RE: LFPCN 41357 - Littelfuse TVS DO-214AB Package Lead Frame Optimization

PCN Report

Prepared By : Hellen Yang – Sr. Product Engineer,
Date : 8/18/2020
Device : DO-214AB Leadframe molding lock & V groove optimization
Revision : A

2.0 Applicable Devices:

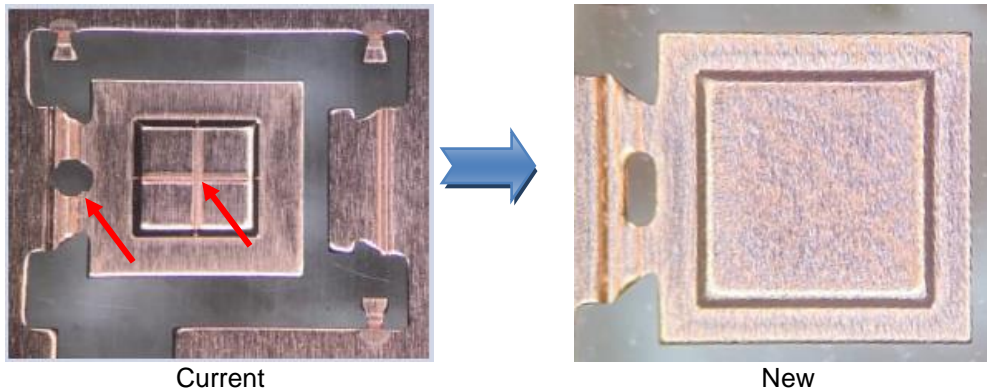
The purpose of this project is to qualify DO-214AB TVS with optimized leadframe mold lock design & remove V groove to reduce trim & form stress and soldering stress. Succeeding pages summarize the material and reliability test performed in qualification lots.
